## **BID ADDENDUM NO. 6**

### **Johnson Student Center**

### **Building Demolition, Increment 1 (Demolition) and Increment 2**

RANCHO SANTIAGO COMMUNITY COLLEGE DISTRICT  
SANTA ANA, CA

J209 SSSP UPWARD BOUND - EAST

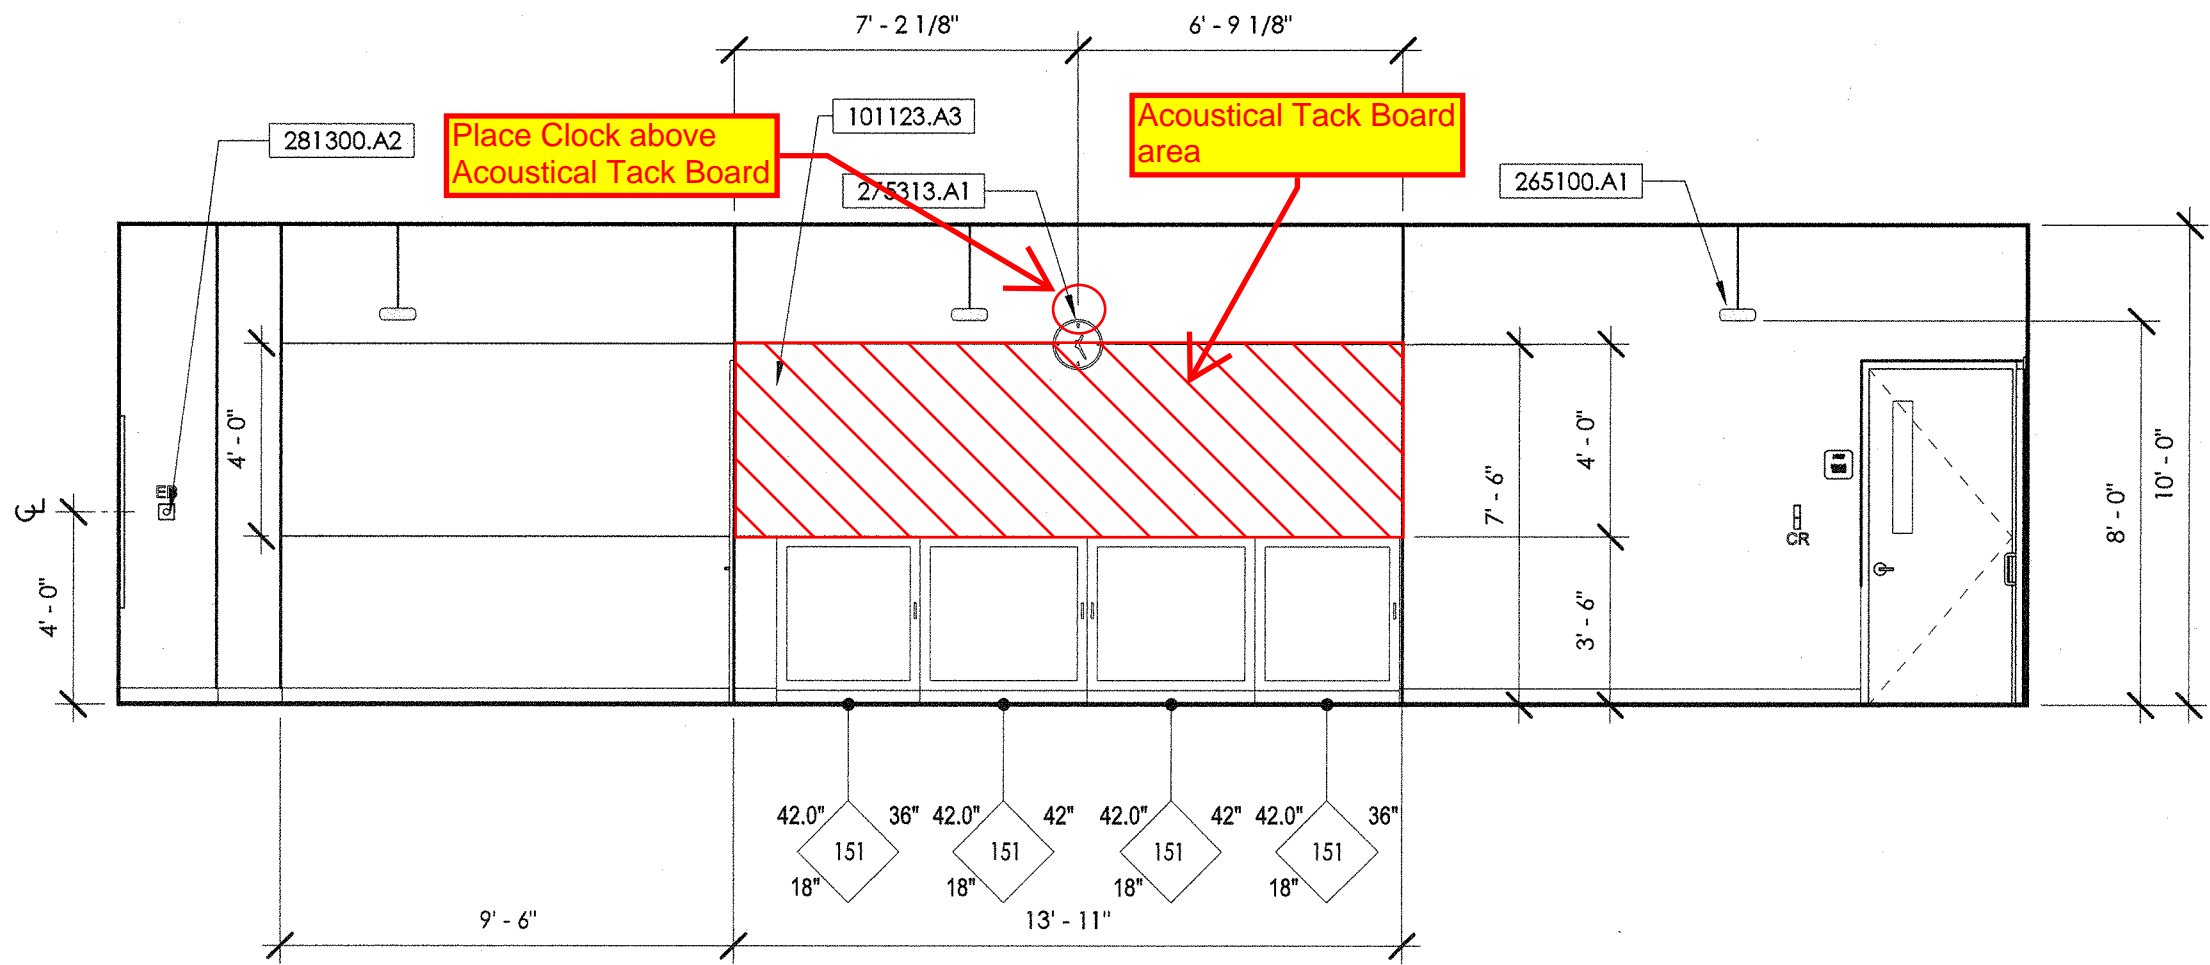
Increment #2 - Sheet A7.25 - Detail 21 - Please confirm if there are one or two Keynote 101123.A3 Acoustic Tack Boards at this elevation, since the left 9'-6" is not called out and the wall is separated from the middle 13'-11" board. Please also clarify the limits of the tack board on the north and south walls of the workroom (i.e. does the tack board wrap around these walls)?

**CANOPY @ LOBBY / PARAPET**

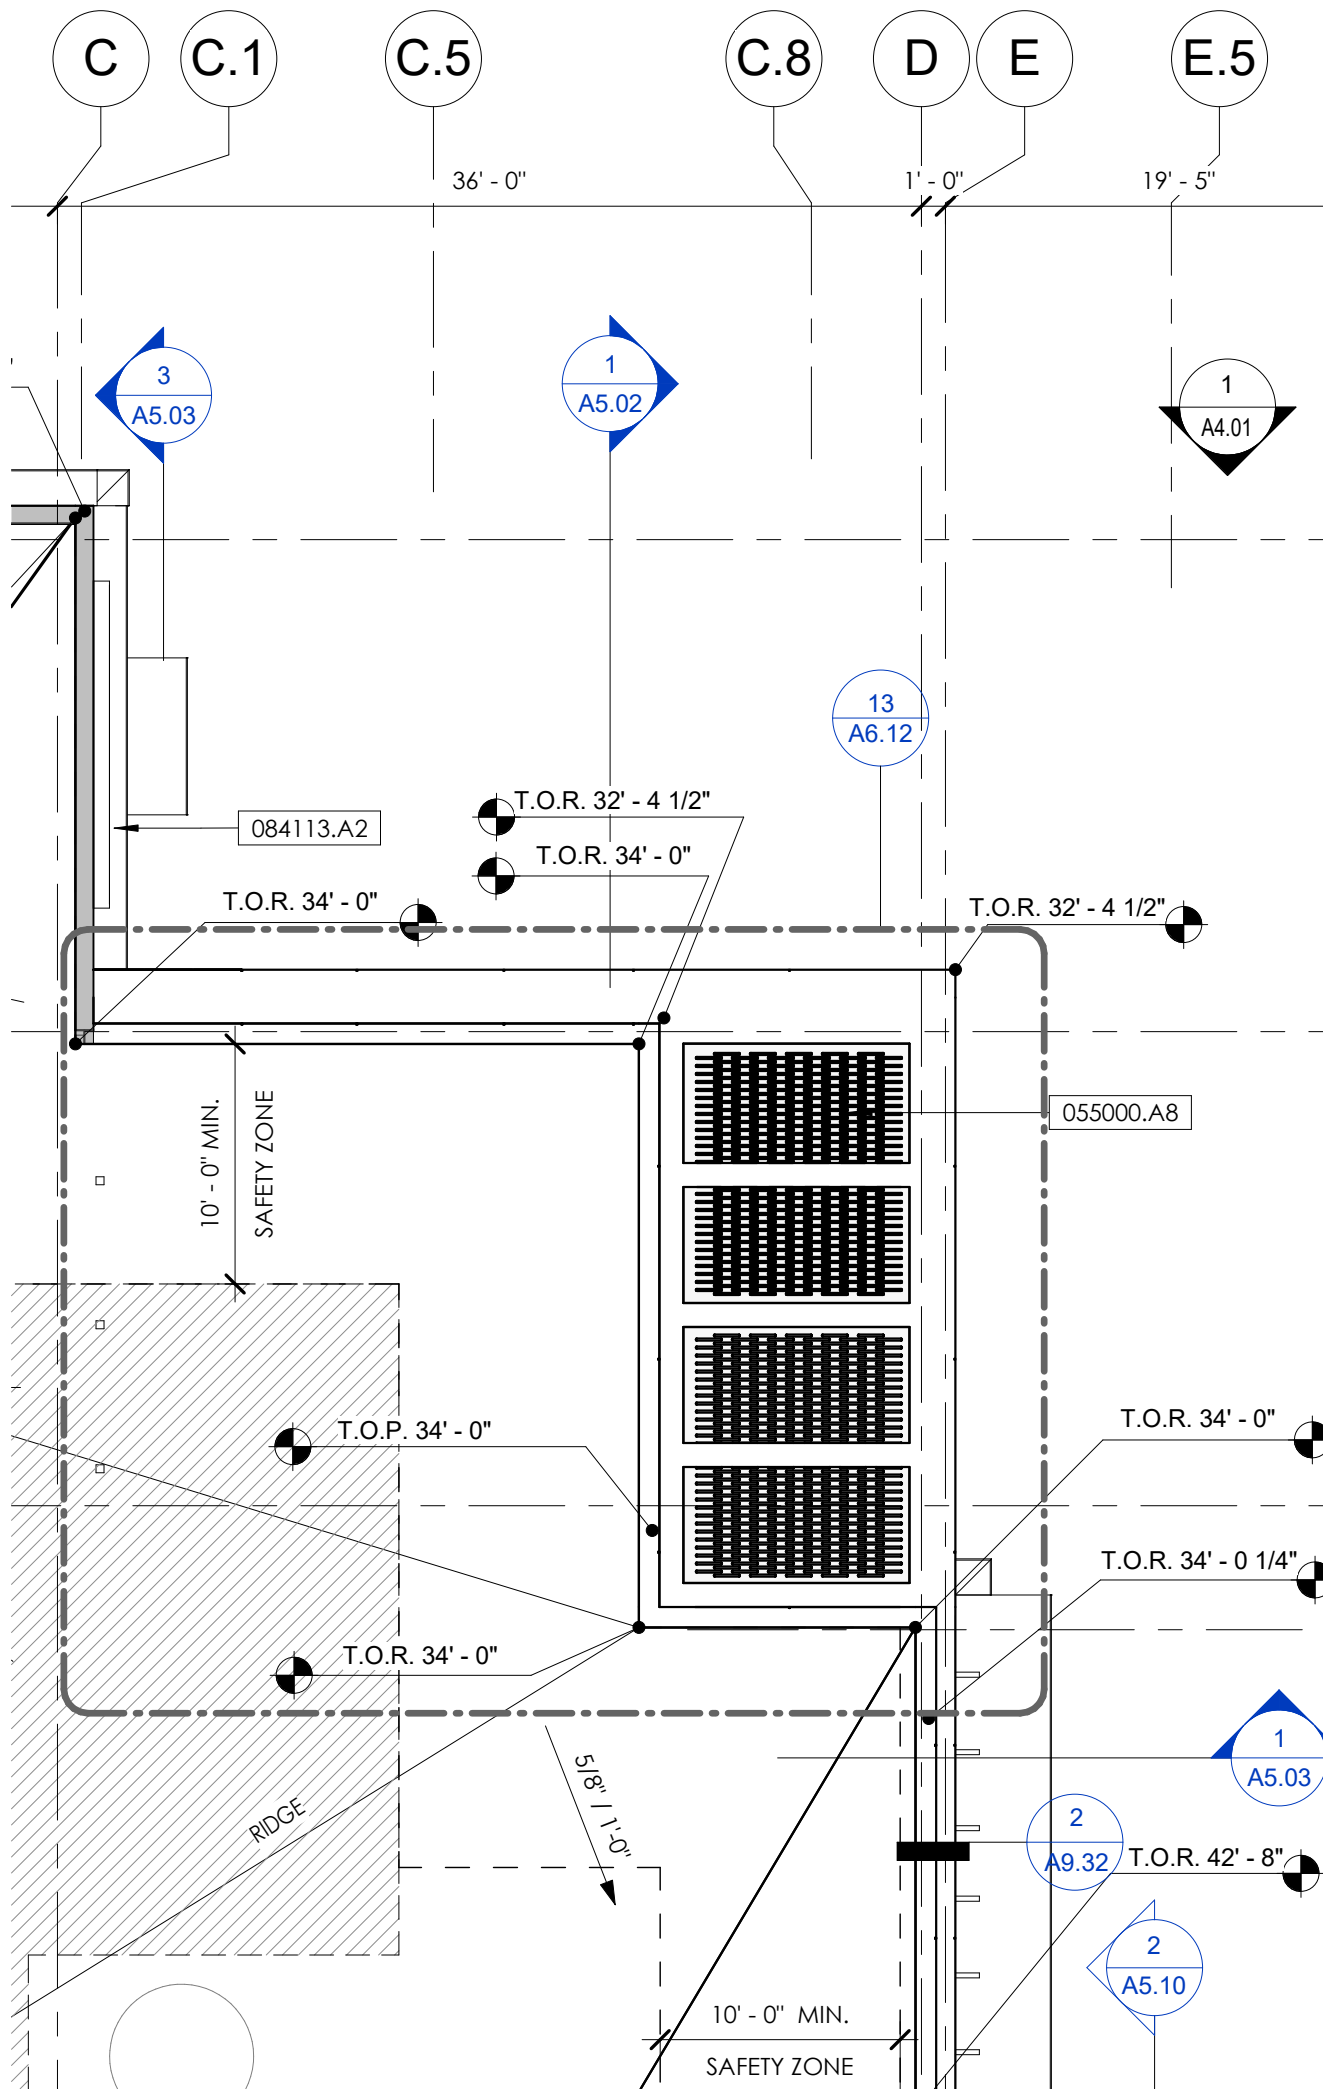
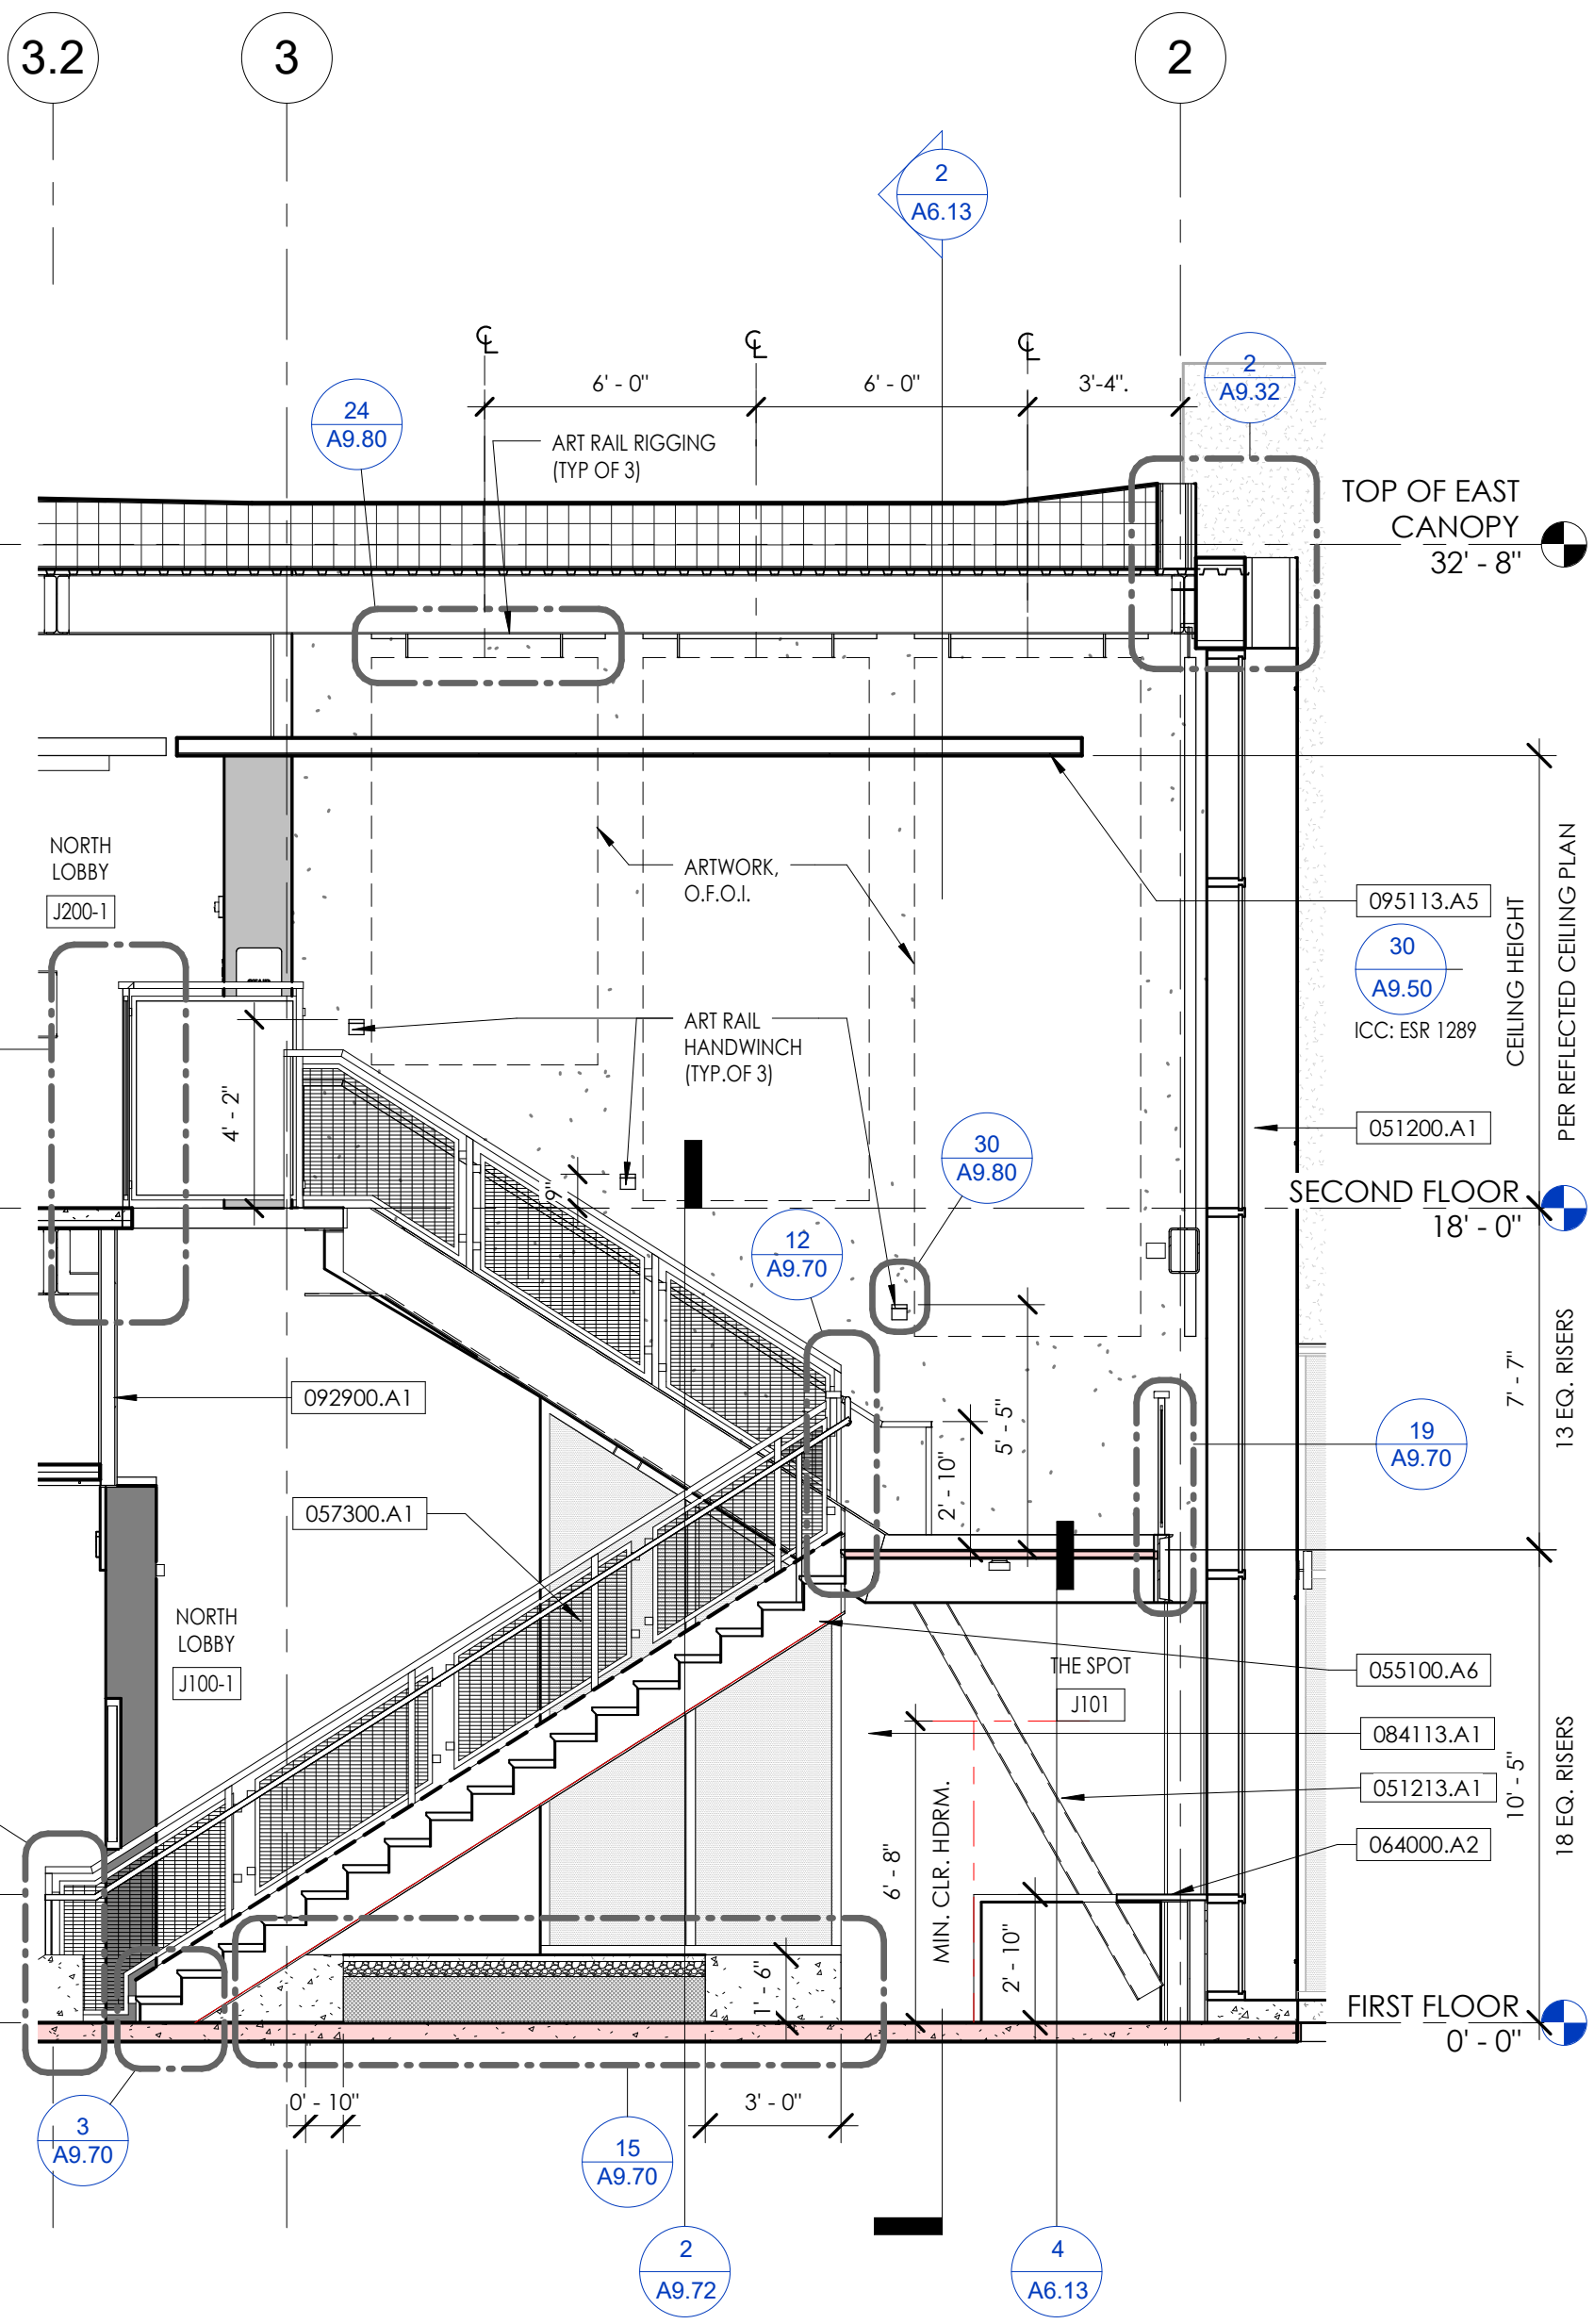
Increment #2 - Sheet A2.30, just north of Gridlines "2" between Gridlines "C" and "D" there appears to be a roof parapet at 32'-4 1/2", however 1/A5.02 takes you to 3/A5.11 which then takes you to 2/A9.32 and there are no details for this parapet. See attached for reference. Please review and advise.

FOR THE CANOPY WITH ROOF PARAPET, SEE ATTACHED REVISED DETAIL 2/A9.32. FOR THE CANOPY WITHOUT PARAPET SEE ATTACHED REVISED DETAILS 5/A9.32. FOR ALL OTHER DETAILS AND SECTIONS SEE ENLARGED ROOF PLAN 15/A6.12. ATTACHED DETAILS, SECTIONS AND PLANS ARE REVISED OTHERWISE USE THE DSA APPROVED SET. DIMENSIONS PROVIDED ON ENLARGED ROOF PLAN FOR MORE CLARIFICATION.
